RS-09-020

LaSalle County Station, Units 1 and 2
Facility Operating License Nos. NPF-11 and NPF-18
NRC Docket Nos. 50-373 and 50-374

Subject: Request for a License Amendment to Technical Specification 3.5.1, "Emergency Core Cooling Systems (ECCS) Operating"

**ATTACHMENT 4B
SIMPLIFIED SCHEMATIC OF THE ADS/LLS INTERFACE
PREVIOUS CONFIGURATION**

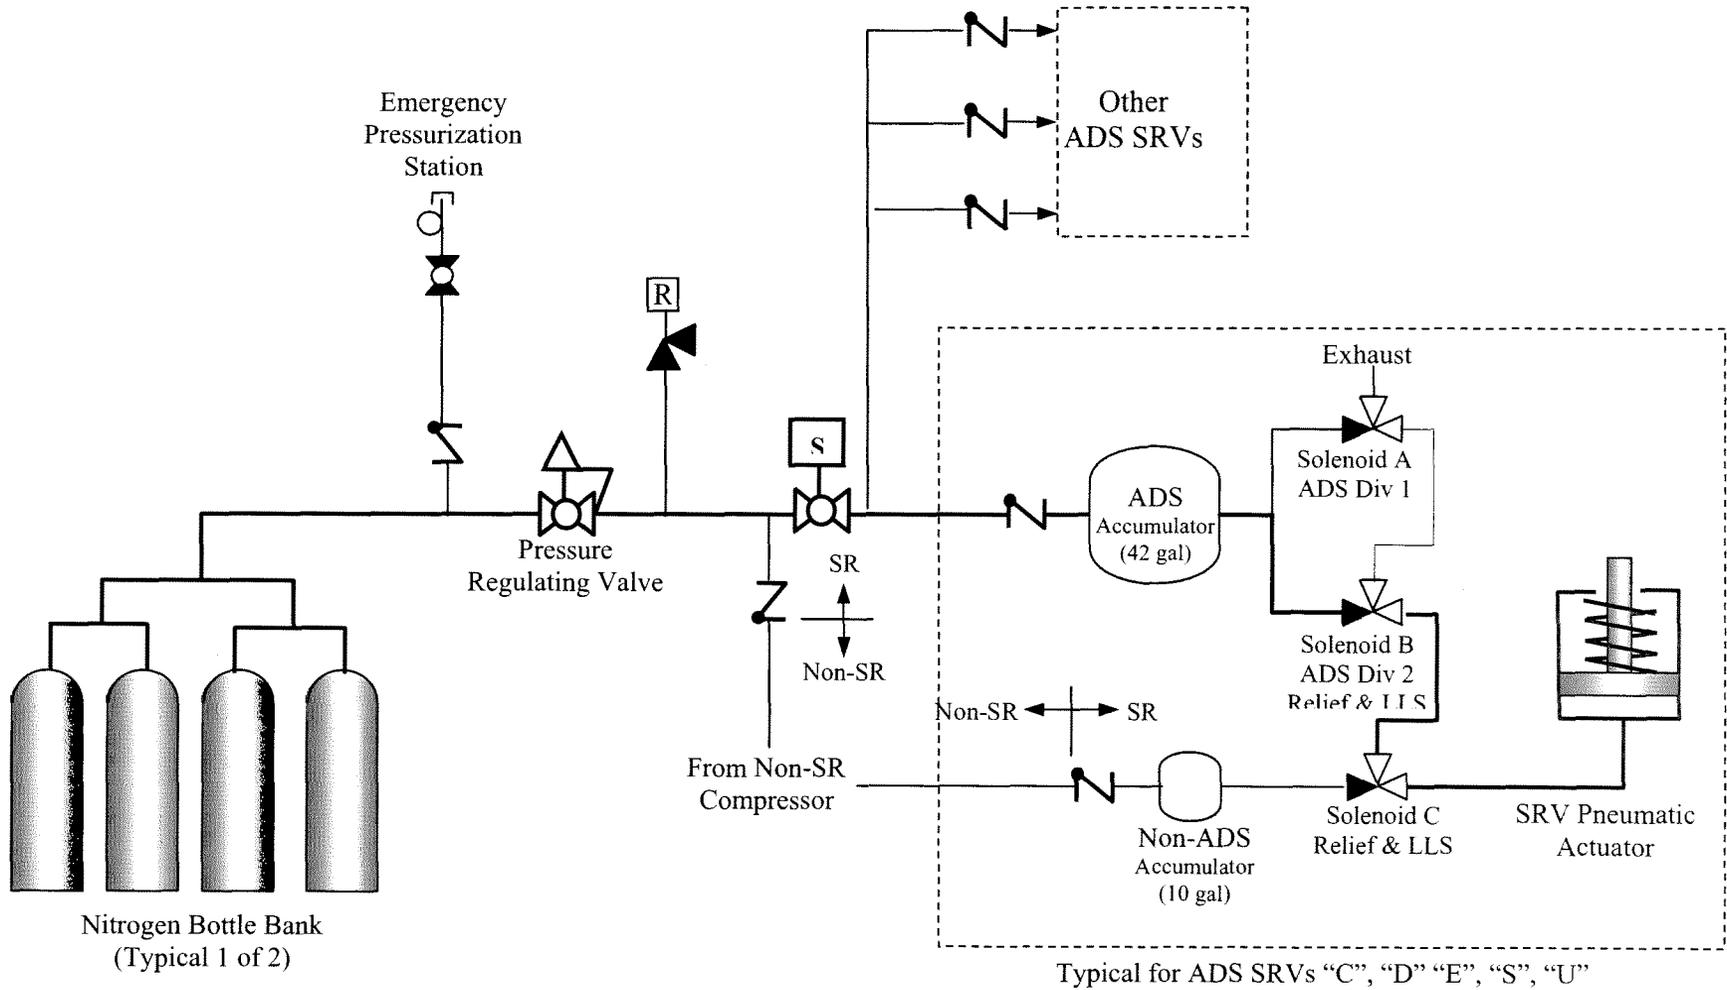
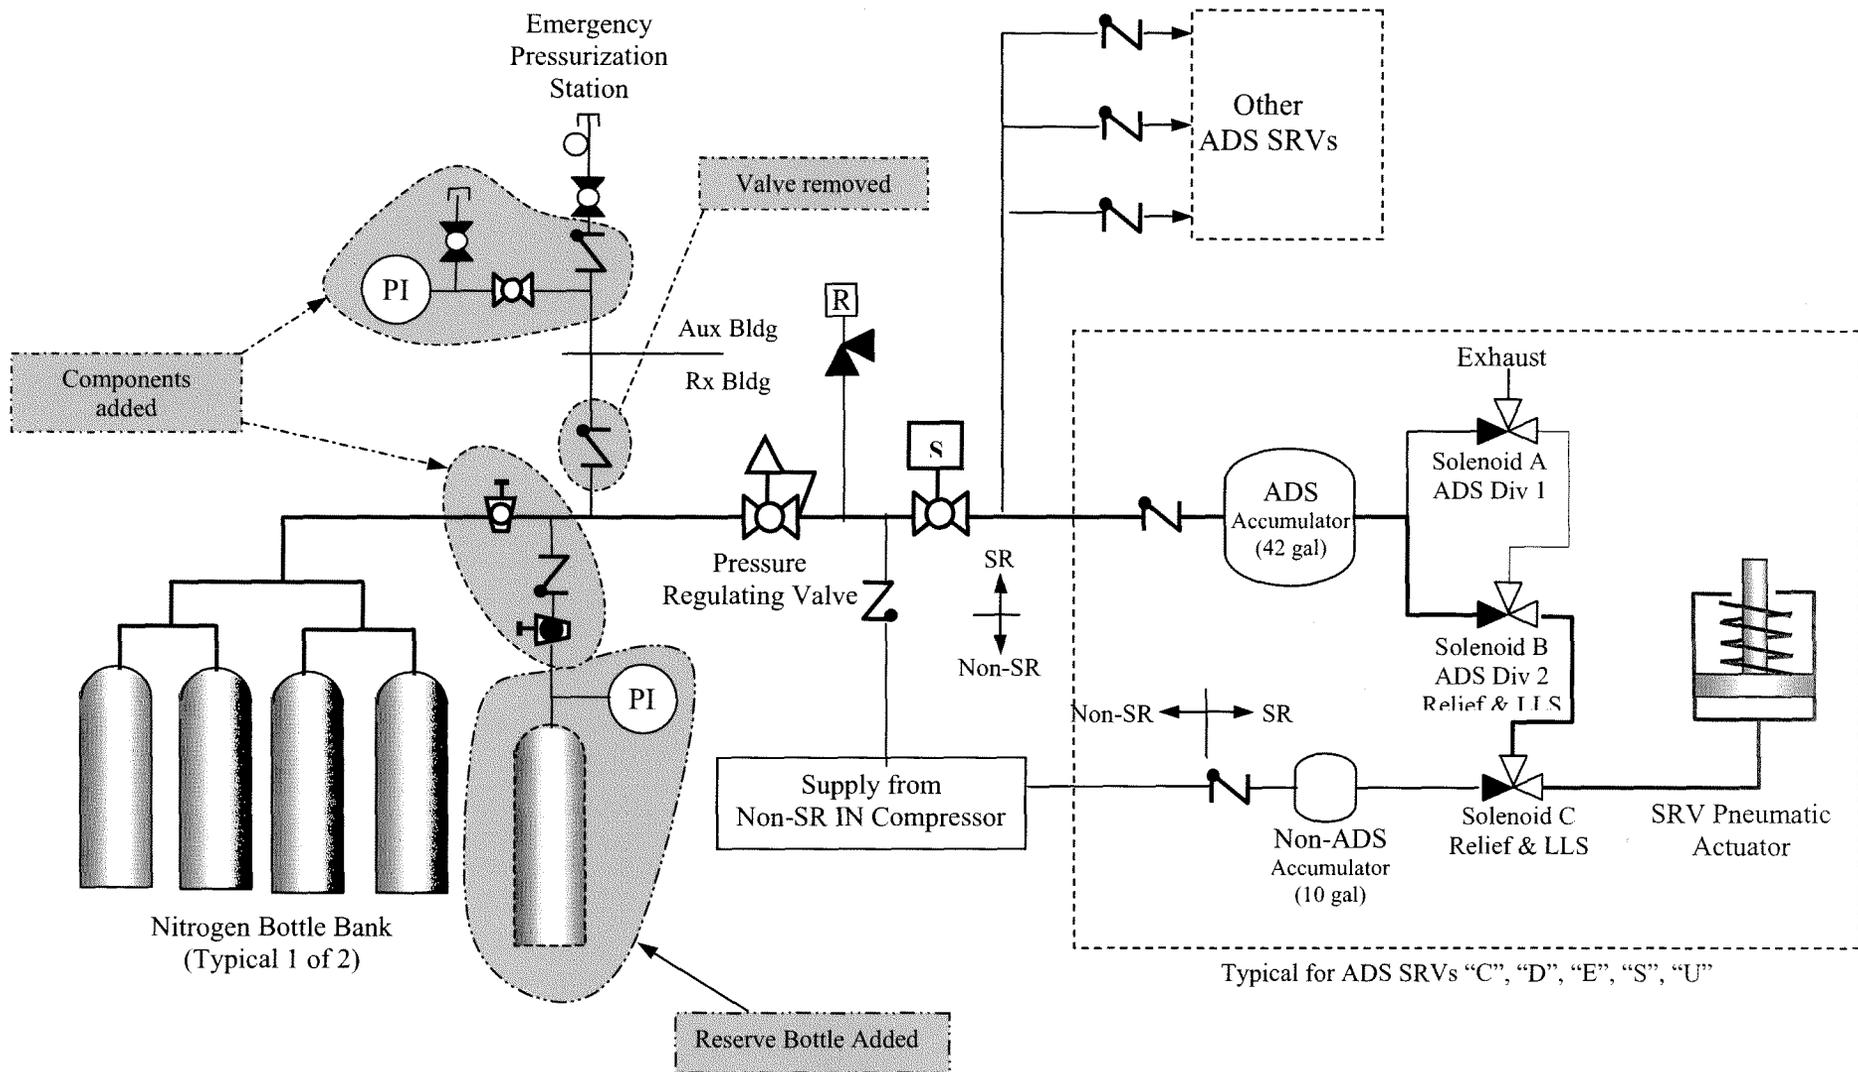
To further ensure the safety function of the ADS SRVs is maintained, a modification has been completed to the ADS accumulator backup compressed gas system for both LSCS Units 1 and 2. The modifications illustrated in Attachment 4C include the addition of a normally isolated reserve bottle at each bottle bank. This reserve bottle is used during bottle replacement activities. Once valved in, the reserve bottle is verified to have a minimum bottle pressure of 1100 psig. This ensures sufficient usable nitrogen exists to support both the LLS and ADS function of the SRVs plus assumed design leakage with no operator action. With the backup compressed gas system bottle pressure of ≥ 500 psig or the reserve bottle pressure of ≥ 1100 psig there is sufficient nitrogen available for any postulated event involving LLS actuation and a subsequent need for ADS.

The following modifications have been completed for both LSCS Units 1 and 2 ADS to enhance the ADS compressed gas system. The details of the modifications are listed below and simple schematics showing the pre and post modification alignment are illustrated in Attachments 4B and 4C.

- A reserve bottle at each bottle bank has been added that can be utilized during bottle replacement. The reserve nitrogen bottle is valved in during the replacement of the four bottles currently installed in each bottle bank to allow for bottle change.
